**TRANSMITTAL OF RESPONSES TO OHIO ENVIRONMENTAL PROTECTION
AGENCY COMMENTS ON THE DRAFT EXCAVATION PLAN FOR THE AREA 6
FORMER PRODUCTION AREA**

**RESPONSES TO
OHIO ENVIRONMENTAL PROTECTION AGENCY COMMENTS
ON THE DRAFT EXCAVATION PLAN FOR
THE AREA 6 FORMER PRODUCTION AREA**

**RESPONSES TO OHIO ENVIRONMENTAL PROTECTION AGENCY COMMENTS
ON THE EXCAVATION PLAN FOR THE AREA 6 FORMER PRODUCTION AREA
(20602-PL-0001, Revision A)**

FIGURE 2-31. EXCAVATION DEPTH VERSUS SAMPLE DEPTH FOR TOTAL URANIUM IN AREA 6

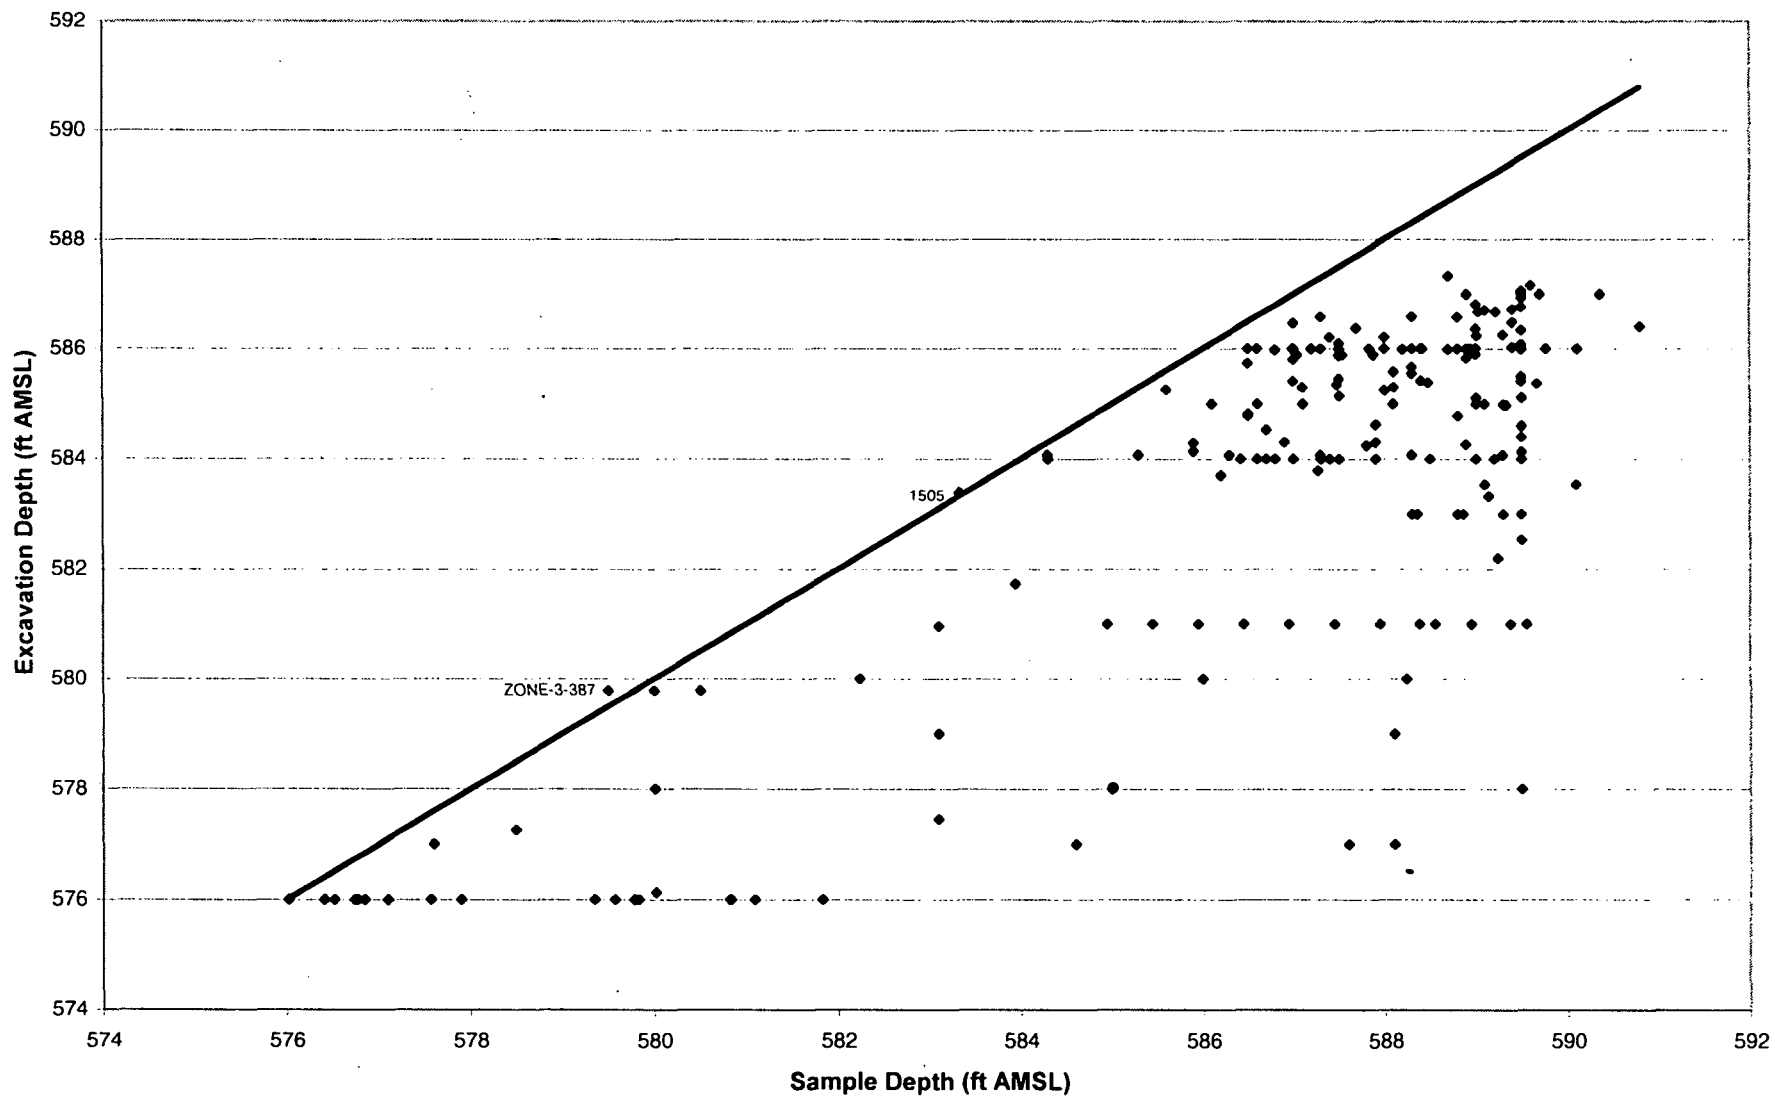
Comment: These two sections describe areas where four historical above-FRL samples are located. Additional samples were not taken due to debris above the locations. These locations need to be captured in this design for excavation. It is unacceptable to plan future sampling for delineation after the Excavation Plan has been submitted. As stated in the SEP, "All area-specific information (e.g., RI/FS and additional predesign investigation data) required to delineate excavation area and conduct soil remediation...will be presented".

Response: During the design of this area, it was not feasible to access these locations for confirmation sampling due to the large debris stockpile. Advancing the excavation another 10 feet in the design based on a single above-FRL interval in boring 1505 without confirmation was determined unreasonable. Instead, it was determined that the excavation would be designed based on the three-dimensional model, which did not capture this isolated interval, and then perform the necessary confirmation borings during excavation control.

However, upon further review of the Remedial Investigation/Feasibility Study (RI/FS) data from boring 1505, it was revealed that the database was populated with an incorrect surface elevation of 583.6 feet above mean sea level (MSL) for this boring. The correct elevation is 588.6 feet. Based on the erroneous elevation, the depth of above-FRL conditions was incorrectly projected at 572.6 feet above MSL when in fact the true above-FRL condition exists only to 577.6 feet above MSL. Therefore, extending the design by a few feet is not unreasonable. The design grade will be adjusted to capture the above-FRL conditions shown in boring 1505, which will also capture the other borings mentioned in this section. Attached is a revised scatter plot showing the true depth of above-FRL uranium compared to the design grade. Once the design is modified to capture all above-FRL contamination, the scatter plots will be corrected and submitted with the final revision of this plan.

Action: The excavation design will be adjusted to capture the additional excavation depth for boring 1505. The scatter plot, Figure 2-31, will be updated with the correct MSL for boring 1505 and the adjusted excavation depths for borings 1281, 12531, 11230, and 1505. The updates to the scatter plot and the excavation drawing, Grid 1, will be submitted in the final Excavation Plan.
